File: 01-MEN-1-43.3/44.1
01-401101
Albion River Br. #10-0136
Bridge Replacement

Subject: Advance Planning Study Pricing Update

Attached is the Advance Planning Study pricing update for the Albion River Bridge replacement alternatives that were studied in 2009 (see the APS Transmittal memo from Jeff Sims to Ilene Poindexter dated April 27, 2009).

ALTERNATIVE 3B

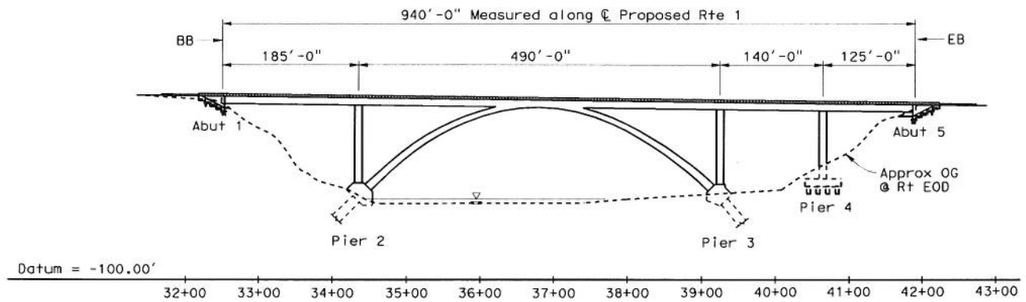
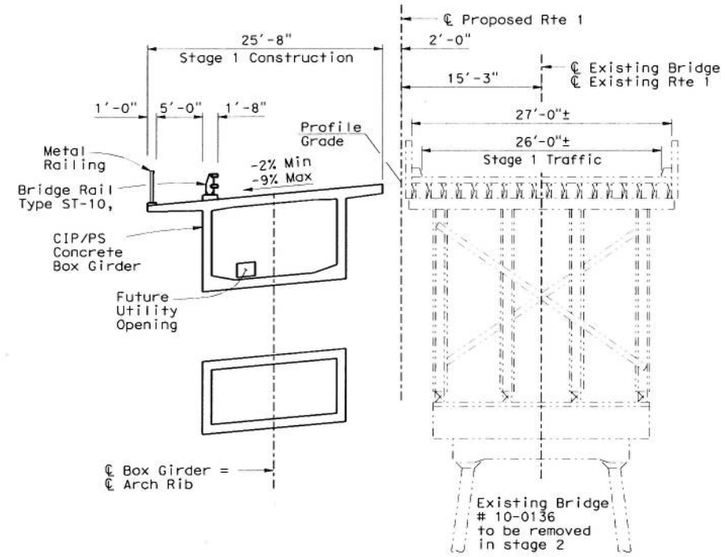
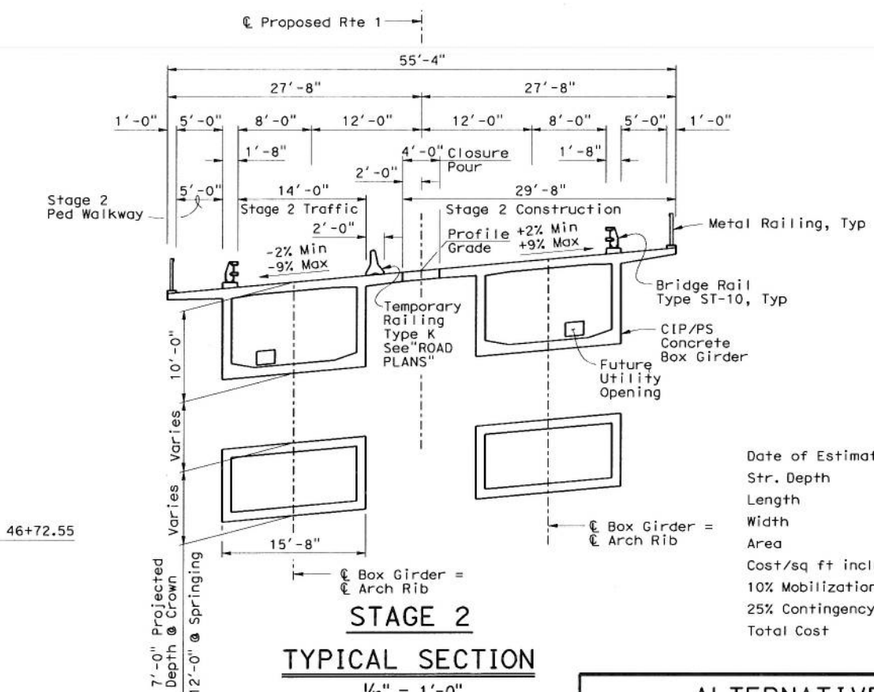
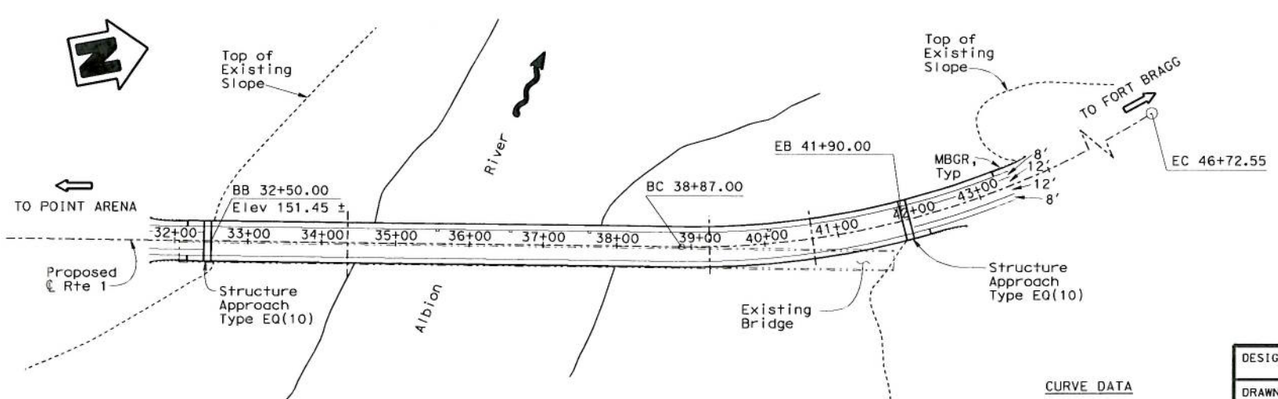
Date of Estimate	5-17-13 ~~4-27-09~~
Str. Depth	Varies
Length	940.00 ft
Width	55'-4"
Area	52,013 ft²
Cost/sq ft including 10% Mobilization & 25% Contingency	$855/d ~~$905/sq ft~~
Total Cost	~~$47,055,700~~ $44,474,000
